CONTRACT NO. 1799

SOLIDS THICKENING AND DEWATERING IMPROVEMENTS

ADDENDUM NO. 2

CONTRACT NO. 1799
SOLIDS THICKENING AND DEWATERING IMPROVEMENTS PROJECT

400-ET-124
DEWATERING BUILDING
ELECTRICAL - MEZZANINE ENLARGED PLAN

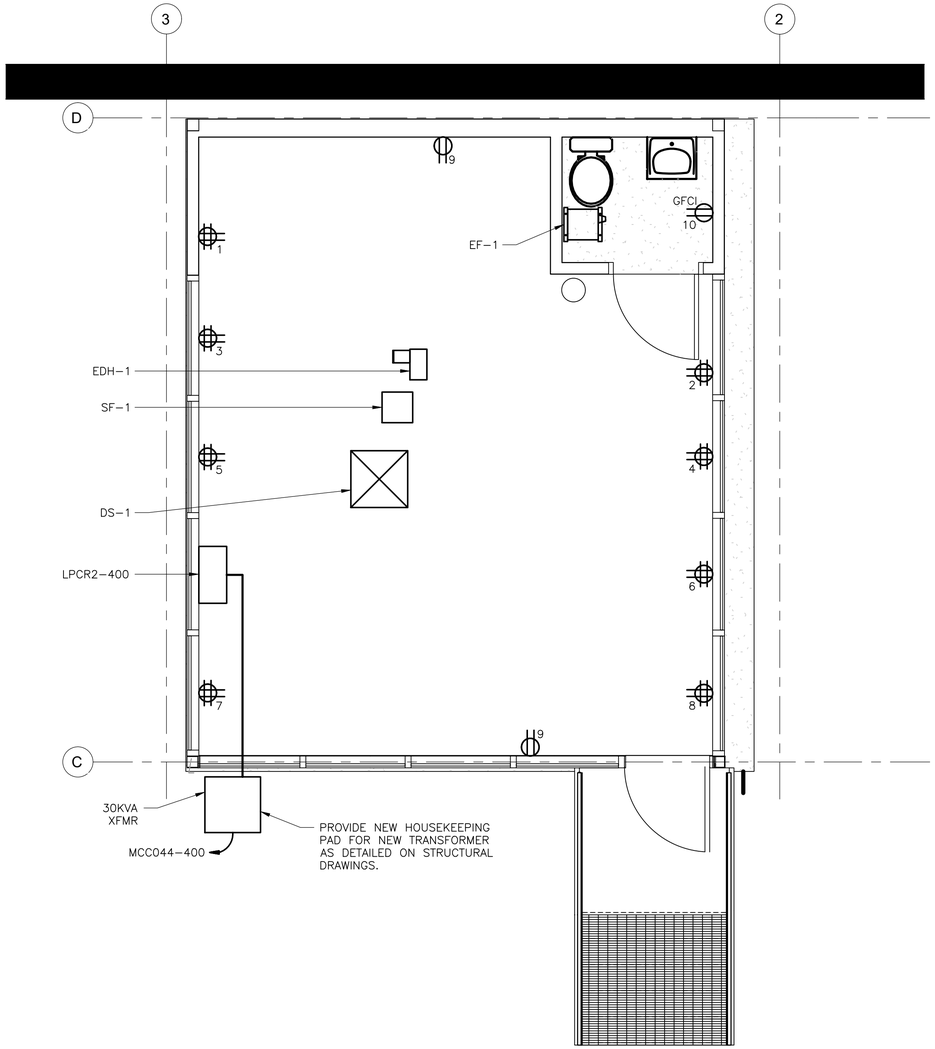
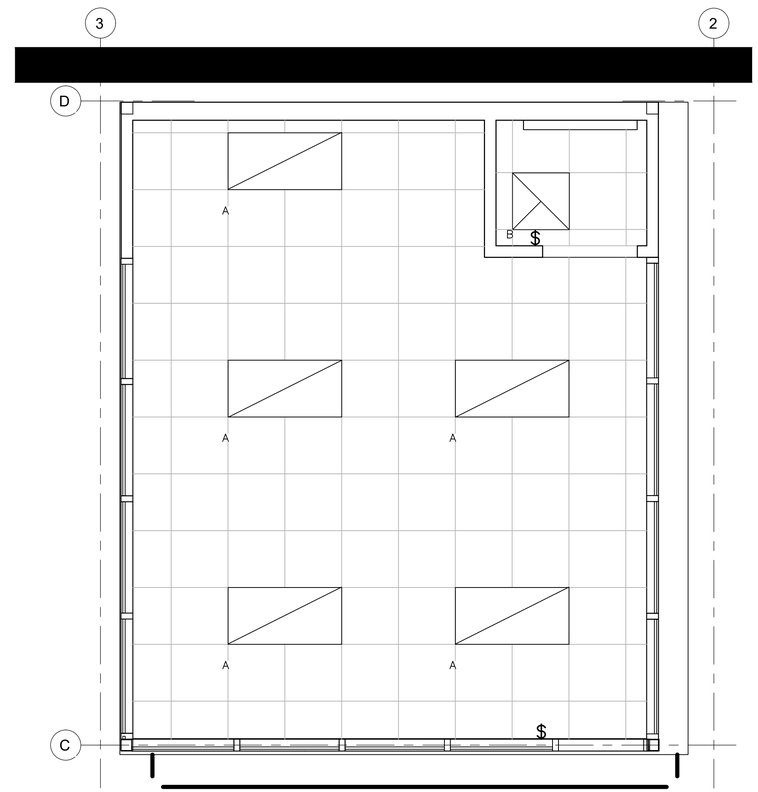
Q24: Ref. 400-et-124
Is all equipment being fed from the LCPR2-400 panel indicated in the new control room.
A24: Yes, see Changes to the Drawings in this Addendum No. 2.

Q25: Please provide panel schedule for panel LCPR2-400.
A25: See Changes to the Drawings in this Addendum No. 2.
